Awel y Môr Offshore Wind Farm

Applicant's Response to Marine Licence Application Consultation Comments

Document Reference: ML-1.2

FIGURE NUMBER:
Figure 1

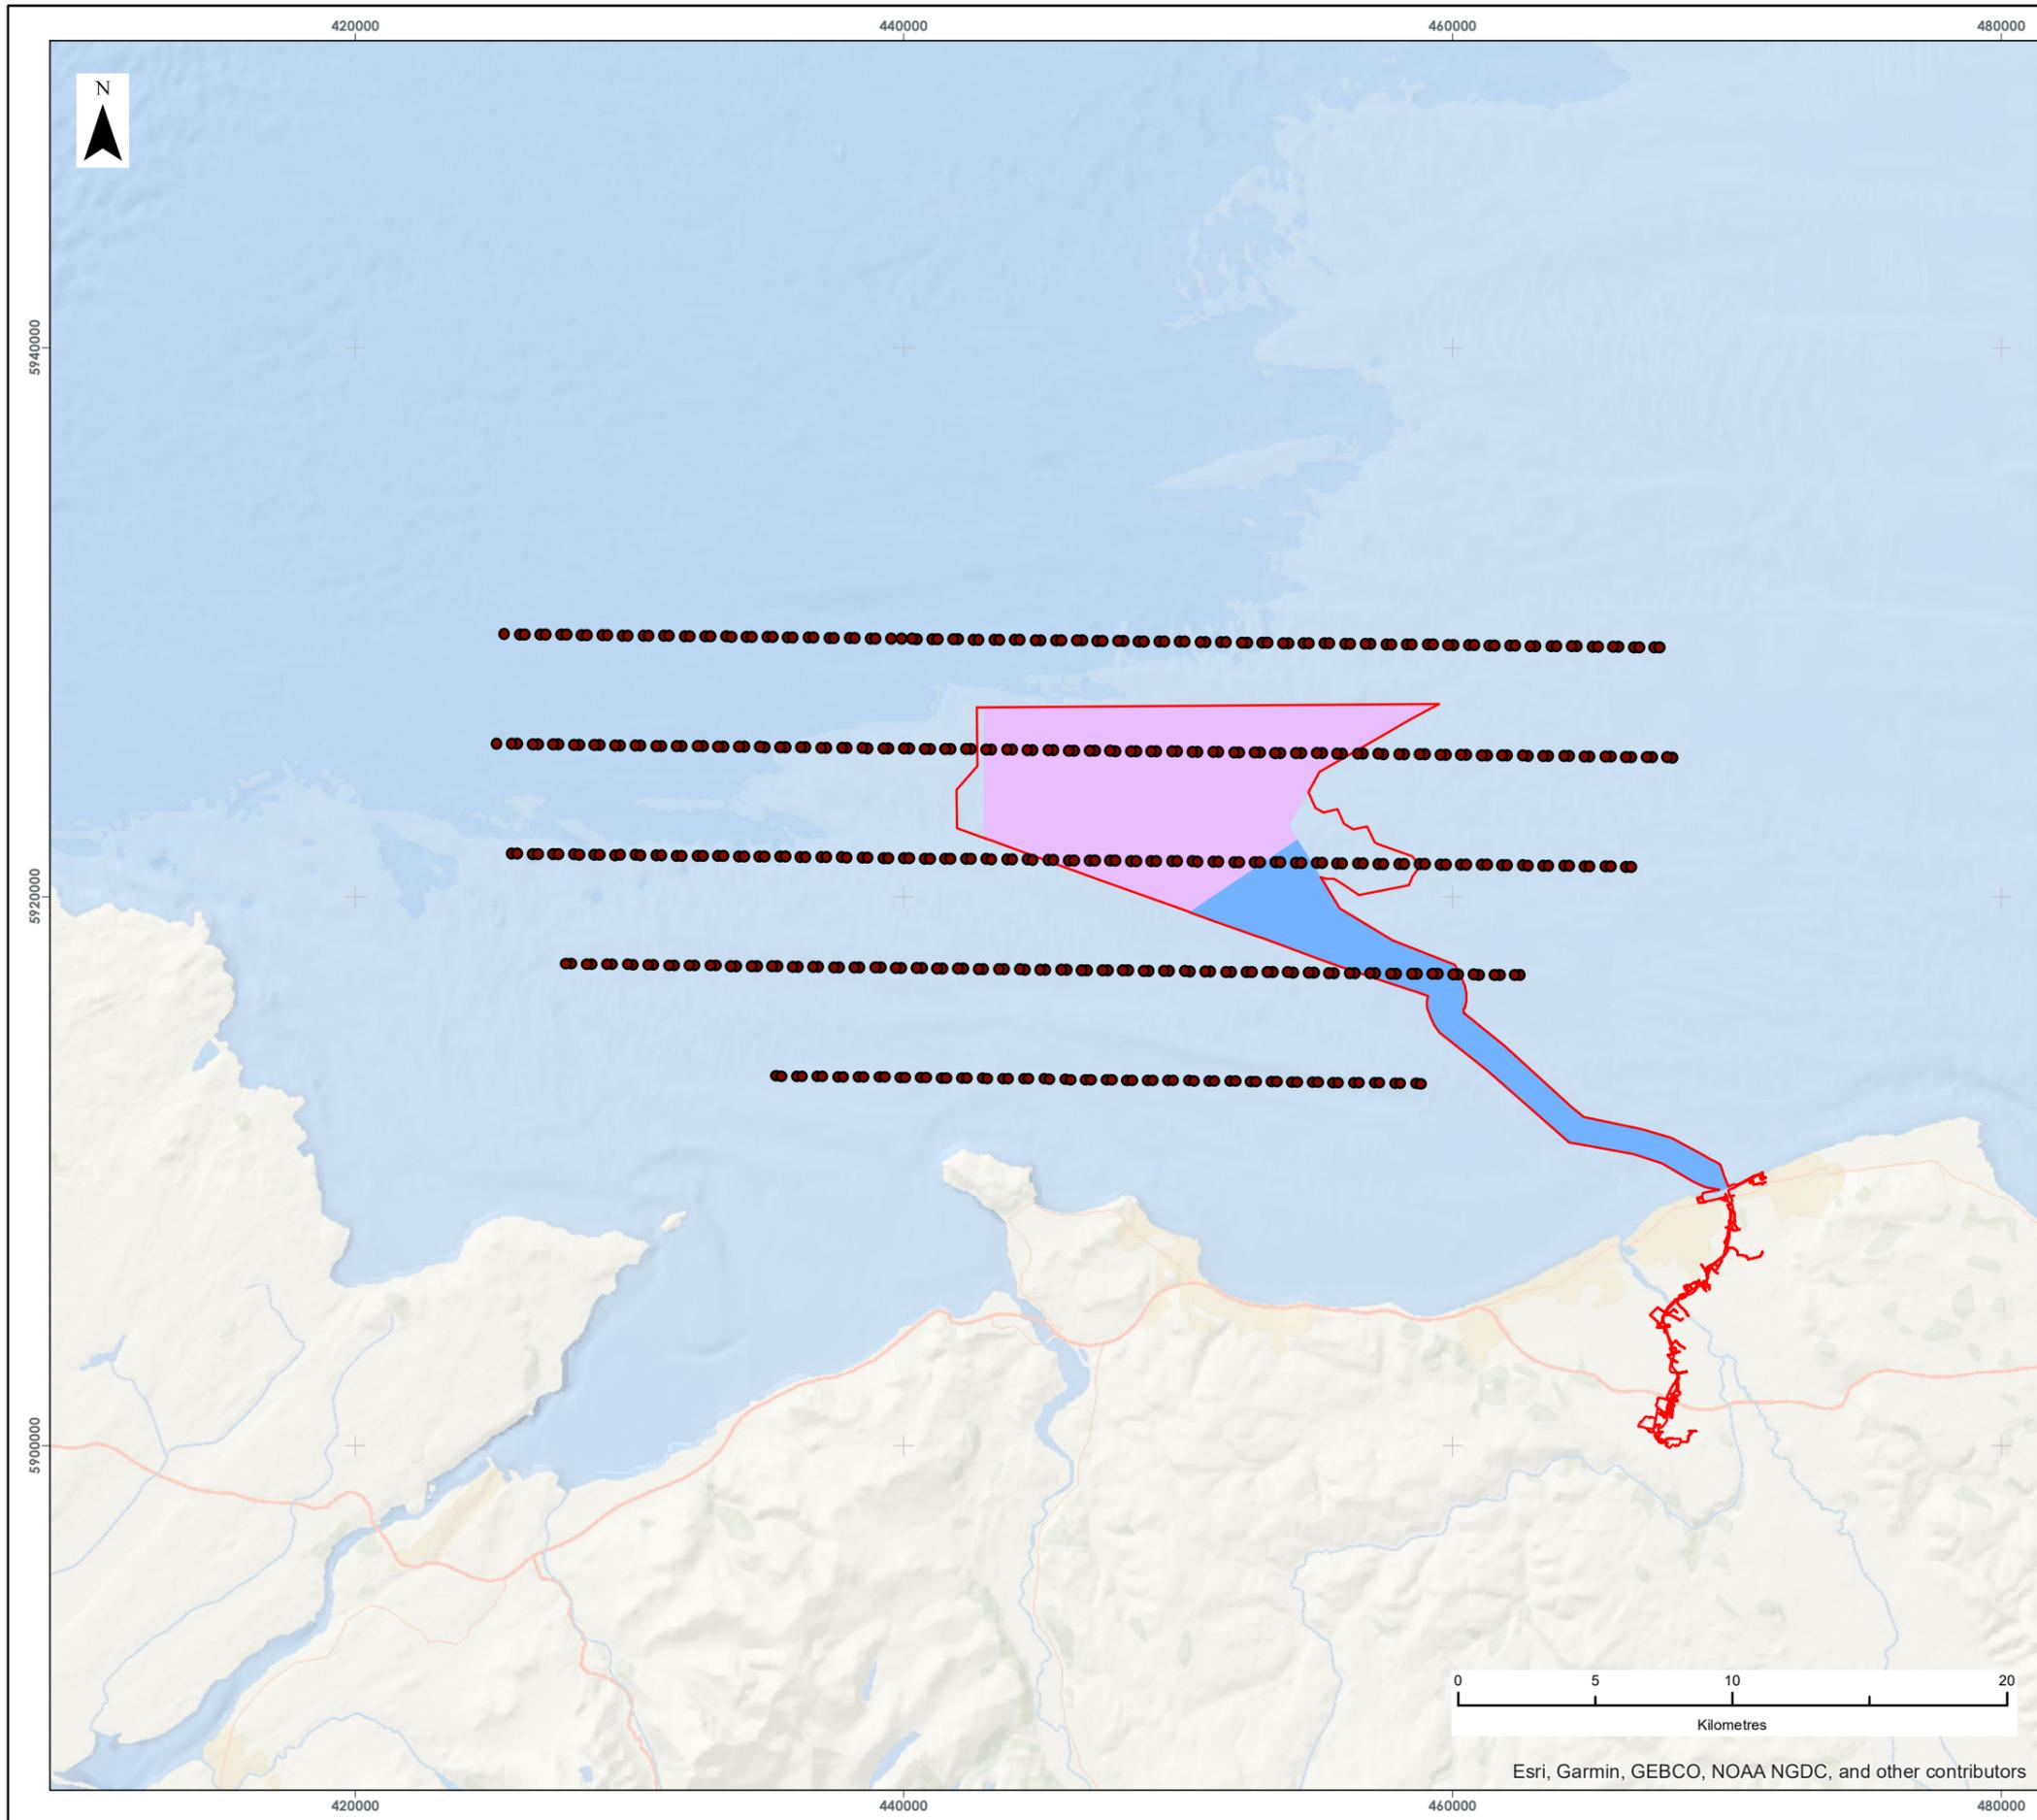
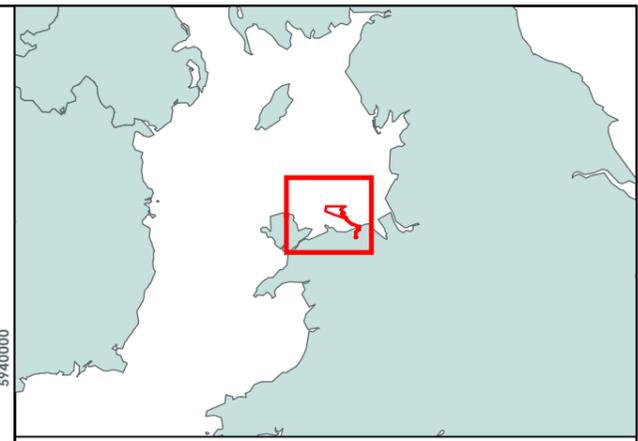
REFERENCE	STAKEHOLDER COMMENT	APPLICANT'S RESPONSE
ML-NRW(A)-7.75	We note the commitment by the Applicant to produce and implement a Vessel Traffic Management Plan in consultation with NRW (A). Whilst it appears that this relates solely to ornithological interests, we recommend that the Plan also appropriately considers marine mammal interests. We advise that such a plan is secured as a condition in the ML.	
ML-NRW(A)-7.76	A number of figures in the revised marine mammal Chapter 7 (6.2.7) appear to be incorrect. For example, Figure 21 is supplied in place of Figure 19, and Figure 21 does not contain all the necessary data layers either time it is presented. Corrected figures should be supplied alongside confirmation of the nature of any revisions from the original version – this will provide NRW (A) with confidence that the revisions and assessments have been applied correctly.	Corrected versions of these figures have been provided to NRW via the DCO examination in the Application Errata List (PINS reference REP1-004). These figures are also provided in Appendix A of this document for completeness.
